ANSTY GARDEN COMMUNITY,

DESIGNERS RESPONSE

REPORT REF NO. 2207280-R17

Report title:	Designers Response to Stage 1 Road Safety Audit – A272 Proposed Toucan Crossing
Date:	October 2023
Document reference and revision:	2207280-R17
Prepared by:	Ardent Consulting Engineers
On behalf of:	Fairfax Acquisitions Ltd

Drawing Number **2207280-010** Rev **B**

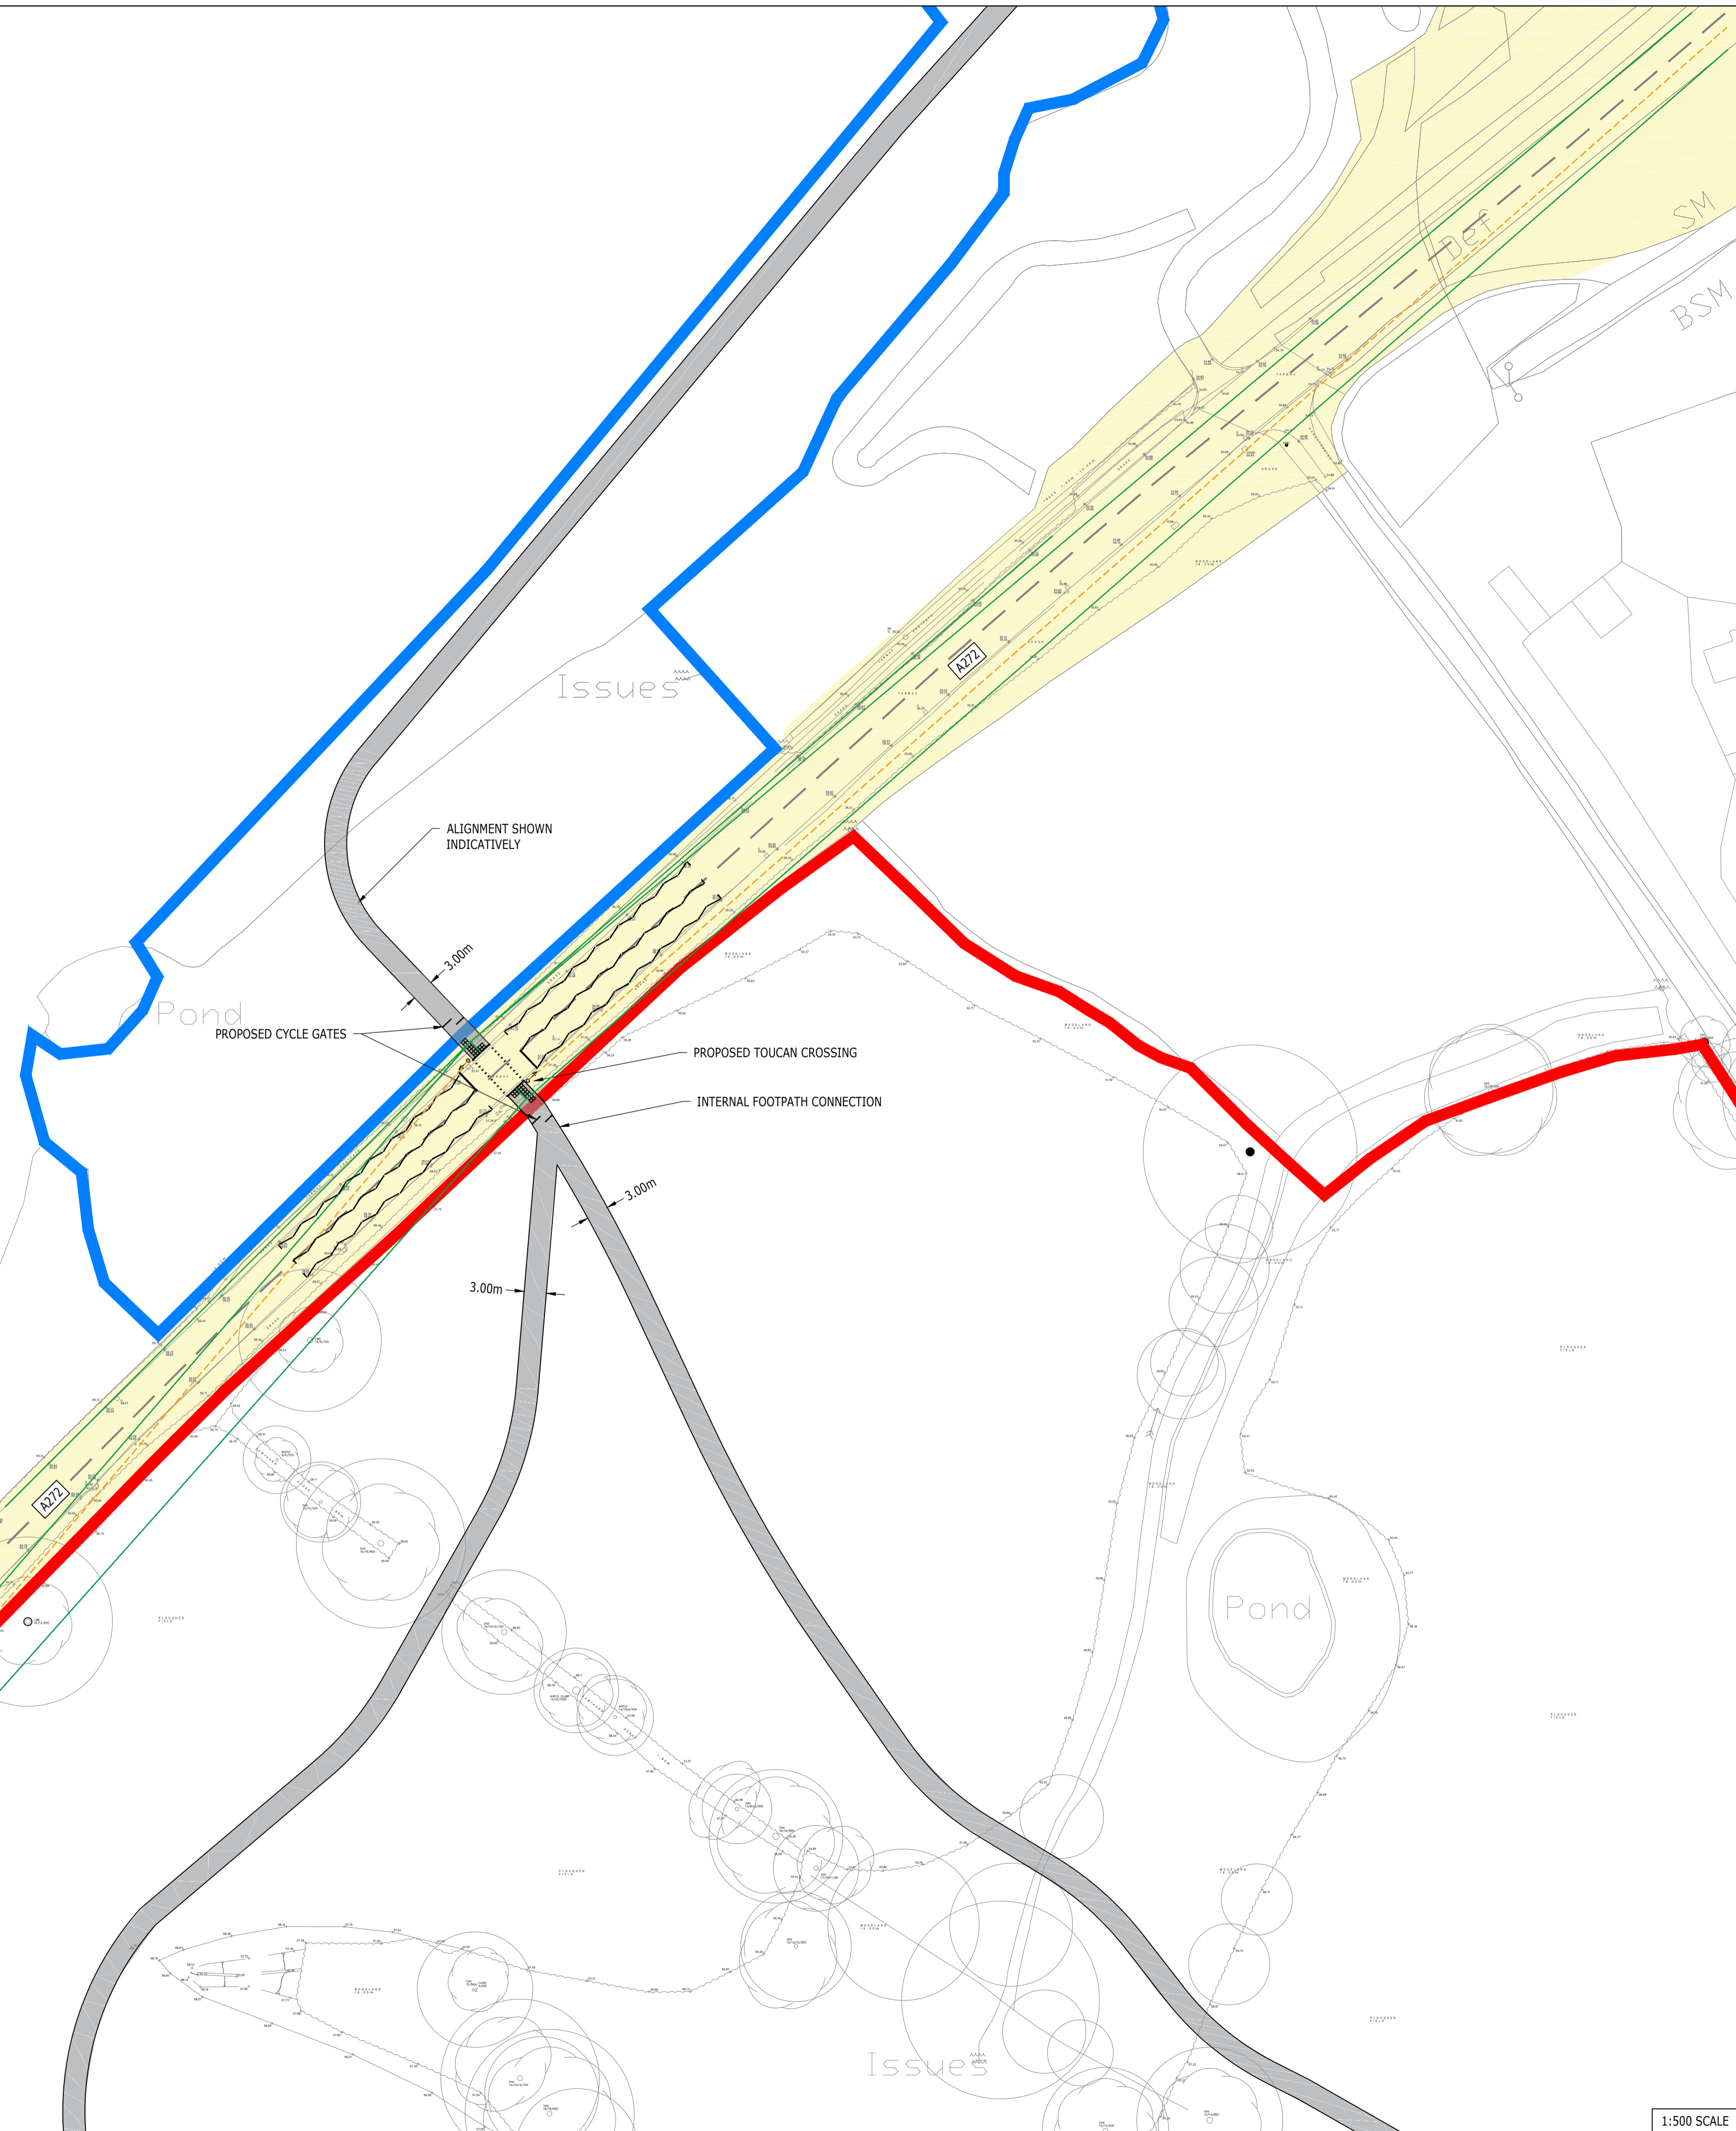
No traffic survey information was provided for assessment, where a National speed limit applies on the A272 at this location. Excessive speeds on the approaches to the Toucan crossing may affect the safe operation of the crossings and could lead to vehicles not being able to stop, leading to possible rear end shunts, or vehicle to pedestrian / cyclist collisions.

No intervisibility splays for pedestrians or forward visibility splays to signal heads has been supplied for assessment. Intervisibility splays for pedestrians and forward visibility to signal heads pass through areas of vegetation. Visibility could be restricted and this could lead to vehicle to pedestrian or rear end shunt collisions.

The zig-zag controlled area is the standard 8 zig zags. This length of zig-zags may provide insufficient warning of the crossing on a high speed road and could lead to failure to stop and vehicle to pedestrian collisions.

The stop lines could be too close to the pedestrian crossings. This may cause a vehicle to stop at inappropriate locations and may also reduce the intervisibility with pedestrians who are crossing, particularly children, which could lead to vehicle to pedestrian collisions.

As per recommendations it has been noted on ACE Drawing 2207280-010B that speed discrimination equipment to be considered if required (to be presented for RSA2).		
<p>3.4.1 Restricted visibility could lead to side impact or rear end shunt collisions.</p> <p>No intervisibility splays for pedestrians or forward visibility splays to signal heads has been supplied for assessment. Intervisibility splays for pedestrians and forward visibility to signal heads pass through areas of vegetation. Visibility could be restricted and this could lead to vehicle to pedestrian or rear end shunt collisions.</p>	<p>It is recommended that vegetation should be removed from the intervisibility splays, and forward visibility splays, and that a regular maintenance programme to retain the visibility splays should be employed. It is also recommended that the SSD should be supplied for assessment at Stage 2 Safety Audit</p>	<p>Visibility splays based on current posted speed limit have been shown to signal heads and from the proposed toucan crossing as shown on ACE Drawing 2207280-010B. Vegetation to be trimmed and cut back to keep visibility splays clear has also been noted on the drawing. Further details will also be provided for Stage 2 Audit.</p>

<p>could lead to sudden braking and rear end shunt collisions or vehicle to pedestrian collisions.</p>				
<p>3.5.2 Length of zig zag controlled area could lead to vehicle to pedestrian/cycle collisions.</p> <p>The zig-zag controlled area is the standard 8 zig zags. This length of zig-zags may provide insufficient warning of the crossing on a high speed road and could lead to failure to stop and vehicle to pedestrian collisions.</p>	<p>It is recommended that the zig-zags should be extended on the approaches.</p>	<p>The proposed road markings for the toucan crossing have been updated as per safety audit recommendations and TSRGD standards. These are shown on ACE Drawing 2207280-010B.</p>		
<p>3.5.3 Positioning of stop lines could lead to vehicle to pedestrian collisions.</p> <p>The stop lines could be too close to the pedestrian crossings. This may cause a vehicle to stop at inappropriate locations and may also reduce the intervisibility with pedestrians who are crossing, particularly children, which could lead to vehicle to pedestrian collisions.</p>	<p>It is recommended that the stop line markings should be set back a minimum of 2.5m from the stud lines.</p>	<p>The proposed road markings for the toucan crossing have been updated as per safety audit recommendations and TSRGD standards. These are shown on ACE Drawing 2207280-010B.</p>

B	UPDATED FOLLOWING STAGE 1 RSA COMMENTS	DV	DH	DH	17/10/23
A	PROPOSED CYCLE/PEDESTRIAN ROUTE SHOWN NORTHERN SIDE OF THE A272 TO BEECHY BOTTOM RESERVE	ADS	DH	KM	28/09/23
Rev	Description	Dwn	Chk	App	Date

Plan attached showing the locations of the problems identified as part of this audit (location numbers refer to paragraph numbers in the report).

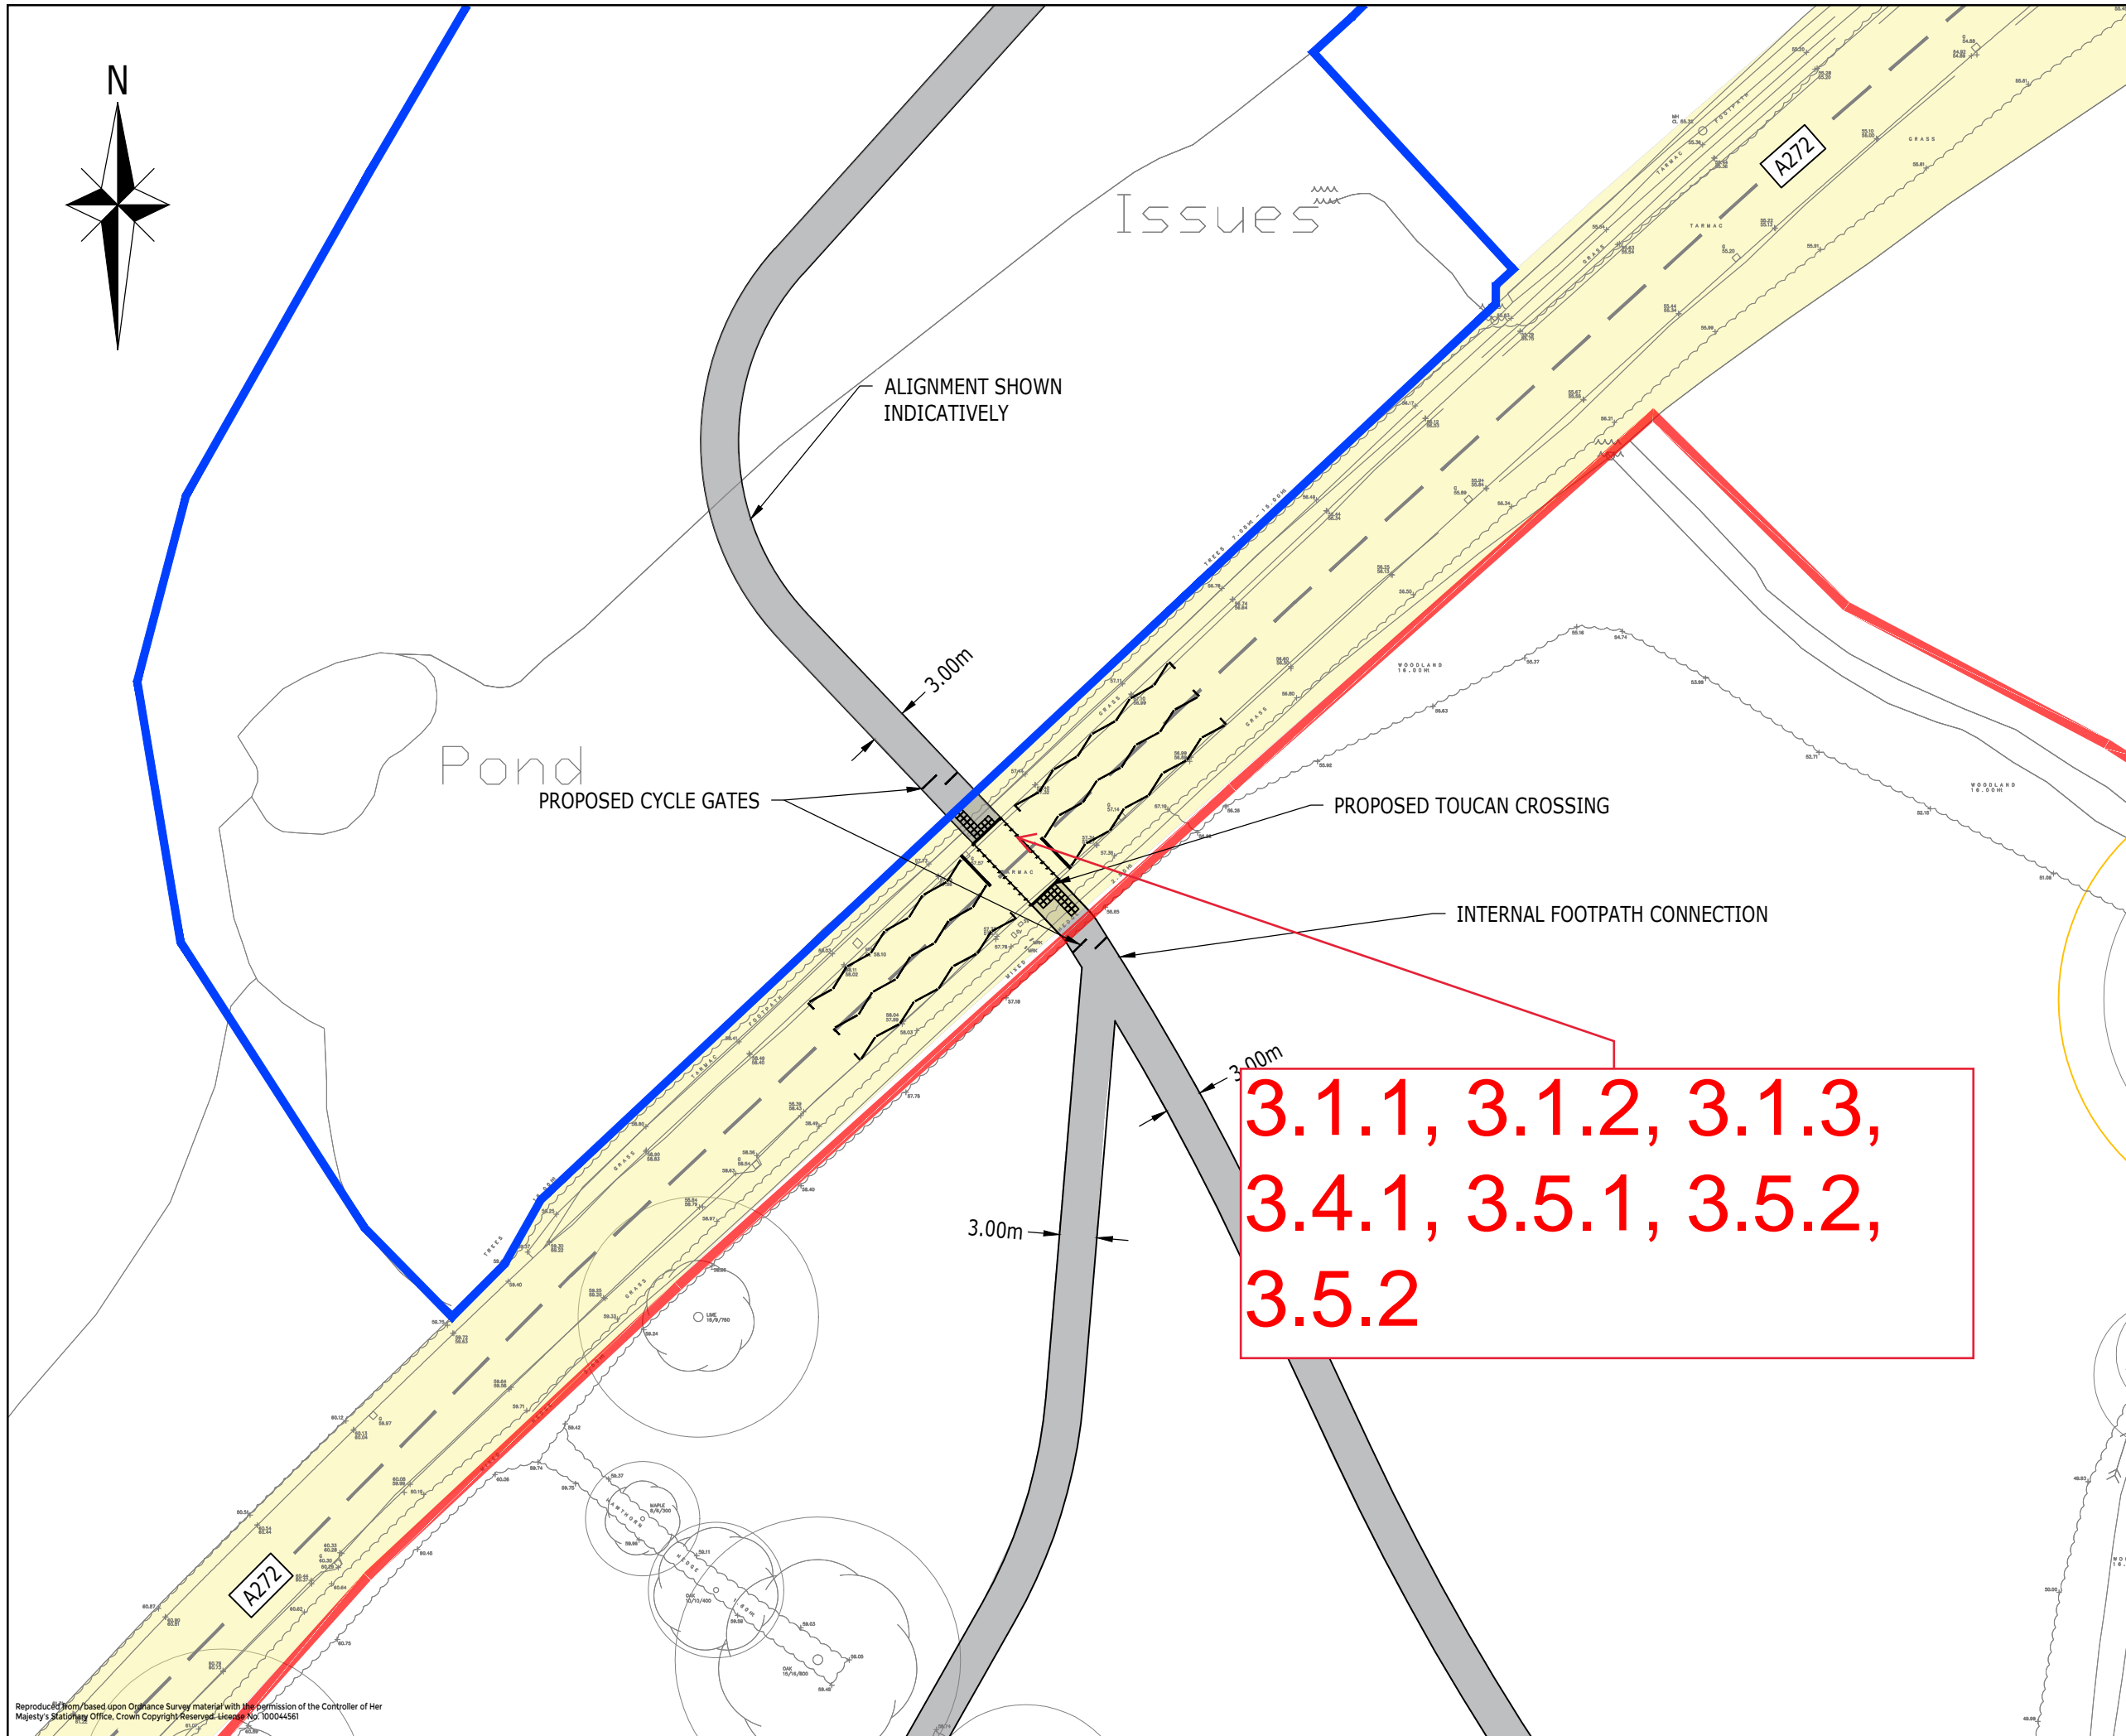
Summary: Irregular usage of the crossing could lead to vehicle to pedestrian collisions or rear end shunts.

Summary: Inappropriate surfacing could lead to vehicle to pedestrian / cyclist collisions or rear end shunts.

Summary: Excessive speed on approaches to signals could lead to vehicle to pedestrian / cyclist collisions or rear end shunts.

Summary: Restricted visibility could lead to side impact or rear end shunt collisions.

Summary: A lack of luminance could lead to rear end shunts or vehicle to pedestrian / cyclist collisions.

Summary: Length of zig zag controlled area could lead to vehicle to pedestrian/cycle collisions.

Summary: Positioning of stop lines could lead to vehicle to pedestrian collisions.
